Client Ref: Lincoln Development Ltd

**Birchs Road Mixed Use Development  
Request for Further Information – 2<sup>nd</sup> Response**

Lincoln Development Limited has lodged an application for resource consent to undertake development of land at the northern end of Lincoln, to provide a mixed-use neighbourhood centre. Stantec was responsible for the associated Transportation Assessment Report<sup>1</sup> that formed part of the application. Selwyn District Council ("Council") commissioned a peer review of this report, and issued a Request for Further Information ("RFI"), for which Stantec prepared a report<sup>2</sup> responding to the RFI matters raised.

Figure 1: Proposed Childcare Centre Parking Layout

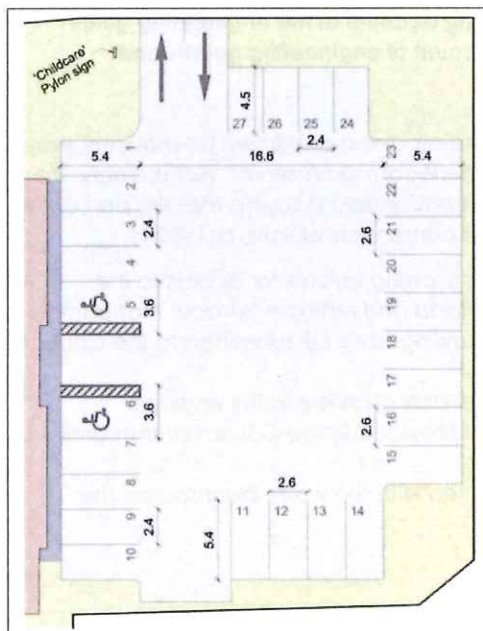
## 3. Confirmation of which parking layout is proposed for the childcare centre and an assessment of this.

*We previously asked that if the layout was different to the one previously presented (as is the case), the layout should be reviewed against the District Plan. However Stantec has discussed solely the number and size of the spaces and no other matters. From a very preliminary assessment, we have identified other non-compliances (such as the requirement to be able to drive forwards into any space without reversing (at Spaces 26 and 27), and no cycle parking being shown) which are not identified by Stantec. We therefore do not consider that an assessment of compliance of the revised childcare centre layout has been provided, as was requested.*

A detailed assessment of the proposed childcare centre's parking layouts compliance with the relevant District Plan Rules, is provided in Table 1 below. For reference, the proposed parking layout is reproduced in figure 1 below.

As shown, the on-site parking arrangements serving the proposed childcare centre align well with the relevant parking standards set out in the District Plan. The matters of non-compliance include a minor shortfall in queuing space, which has been previously assessed in the original RFI response and shown to not present any material adverse effect (as concurred with by the peer reviewer). It is noted that all staff car parks will be clearly demarcated with signage or pavement markings to ensure they operate in line with the intended user categories.
